BURLINGTON DEVELOPMENT REVIEW BOARD

Tuesday May 5 2015

MEMORANDUM

To: Development Review Board
From: Mary O'Neil, AICP, Senior Planner
Date: May 5, 2015
RE: ZP15-0704CA; 61 Summit Street and 411 Main Street

Existing and Demolition Plan

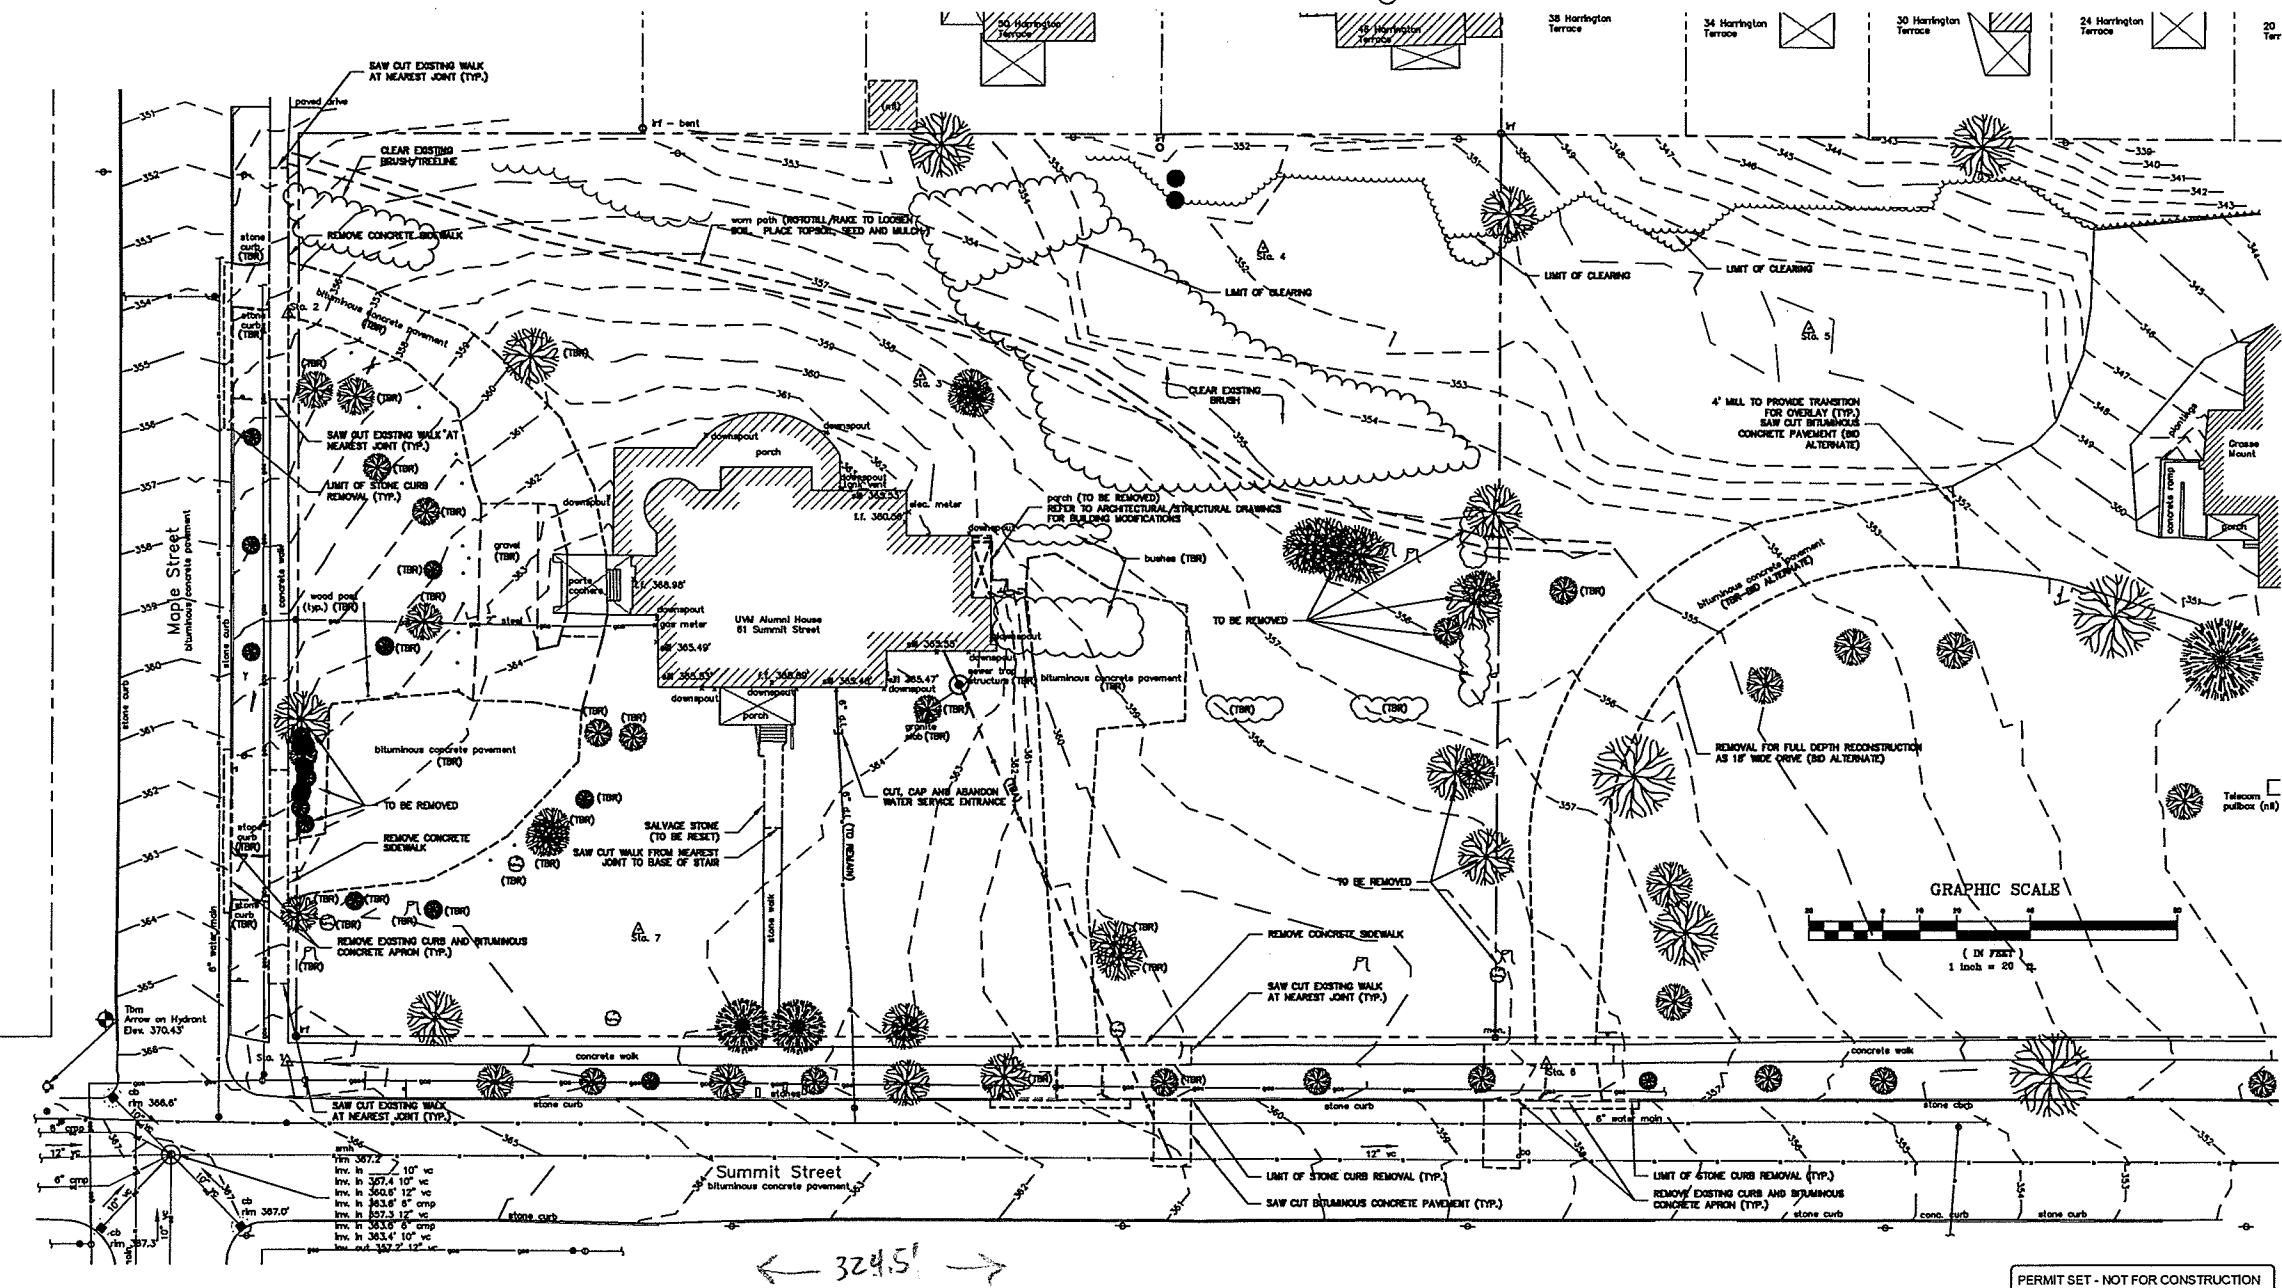
The site falls gradually away to the west, with a collection of large trees both to the west and north. Plan C1.1 defines "clearing existing brush", however that area has plantings that are so large as to escape definition as brush. No specimen trees are identified on the plan. See Section 5.5.4, Tree Removal for review criteria for standards and review criteria. "Evergreen screen" is not a sufficient landscaping proposal (Plan A1.1) A clearly articulated identification of existing landscaping, proposed tree removal and proposed landscaping plan with sizes, species and planting locations/spacing will be a requirement prior to release of the zoning permit.

Plan C-1.1 notes “clear existing brush”, which appears to be much larger growth than suggested. The City Arborist has been contacted to confirm the characterization of existing growth, and to assure no loss of specimen trees in the area of development.

As noted, the City Arborist has been consulted relative to the proposed planting plan. Comparing Plans C1.1 and C1.2, it does not appear any trees within the public ROW will be removed or replaced. Many trees on the south of the Wells/ Alumni House structure will be removed, however. A definitive landscaping plan will be required.

7. A clearly articulated identification of existing landscaping, proposed tree removal and a proposed landscaping plan, with species, sizes and planting locations/spacing, is required **prior to release of the zoning permit**. This plan is subject to review and approval by staff.

C-1.3

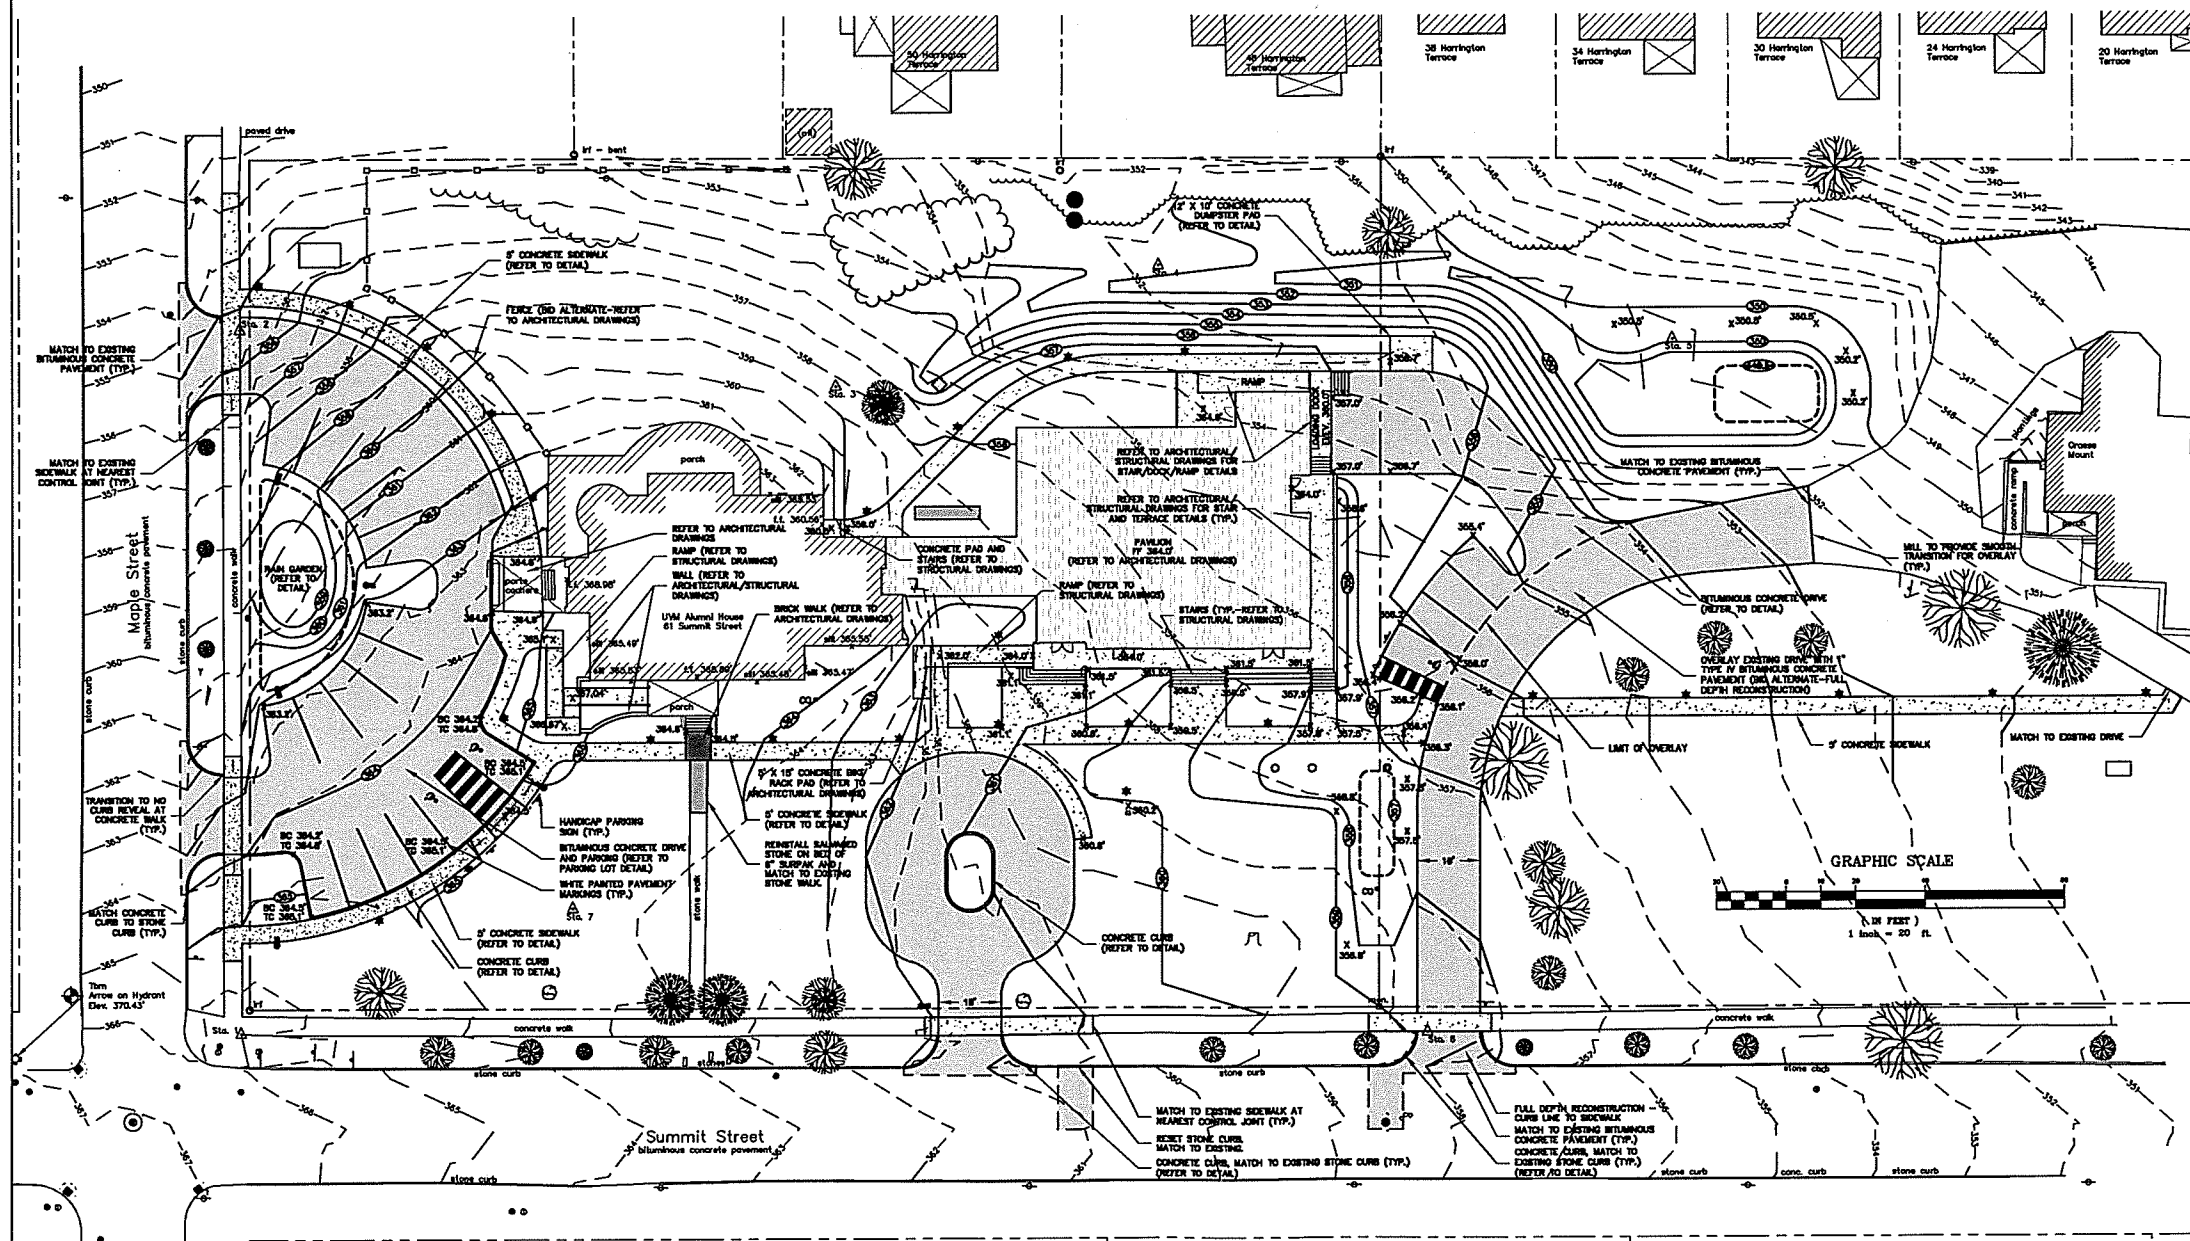
A grading plan has been submitted that reflects efforts to ease the 11' grade change between Harrington Court yards and Wells/Alumni House. See plan C-1.3. **Affirmative finding.**

5 Boundary Fence Detail (Bid Alternate)
SCALE: 3/4" = 1'-0"

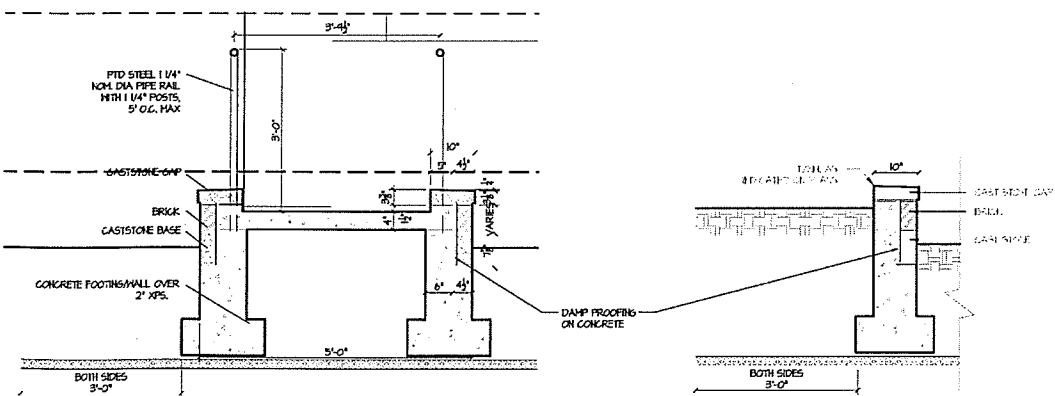
A 4' fence is illustrated on the southwest of the parcel; presumably to ban pedestrian foot traffic in the existing pattern of use. See Plan A6.5 for detail drawing.

From Plan A1.1, it appears that the fence does not meet the required 25' separation from the westerly driveway entrance, as illustrated below. Scaled, it appears to be about 15' from the Maple Street access drive. If the fence location is important to the plan, then the fence must be reduced in height to 3' if within that "clear site triangle."

Affirmative finding if fence meets clear site triangle and landscaping plan provided.

9. The fence is required to meet the "Clear Site Triangle" as noted. Revised plans may be necessary to confirm the location of the proposed fence.
10. All new construction will be required to meet Guidelines for Energy Efficient Construction pursuant to the requirements of Article VI. Energy Conservation, Section 8 of the City of Burlington Code of Ordinances.
